**Bid No. 25-26**

**2025 Alley and Sidewalk Improvements**

**ADDENDUM No. 1**

**May 9, 2025**

**2025 ALLEY AND SIDEWALK IMPROVEMENTS  
DODGE AND MONROE PEDESTRIAN CROSSING**

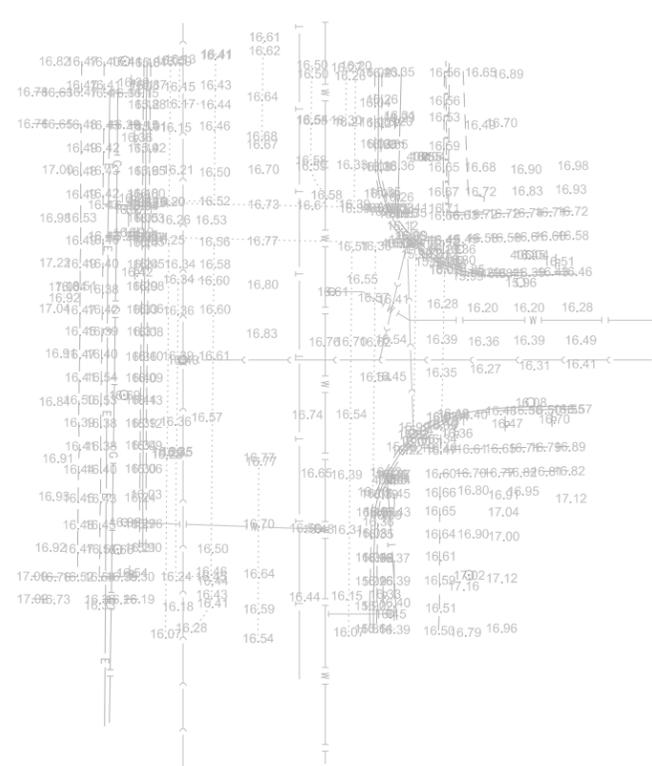
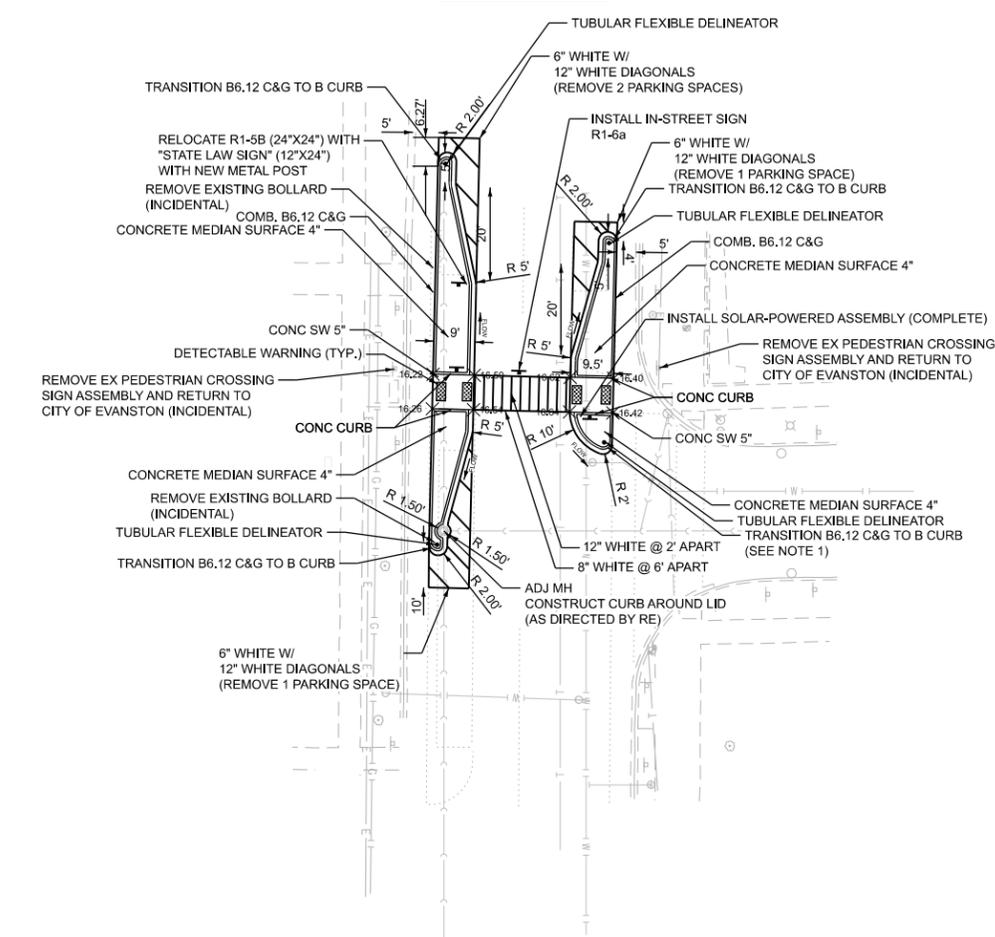
- **DELETE SHEETS 20, 21, 22, and 23 FROM THE PROJECT PLAN SET AND REPLACE THEM WITH THE ATTACHED REVISED PLAN SHEETS 20, 21, 22, AND 23.**

- NOTES:
- ALIGN SOUTH FACE OF CURB WITH MONROE ST FACE OF CURB
  - CURB AND GUTTER TRANSITION TO B-CURB TO BE CONSTRUCTED IN 1 POUR.
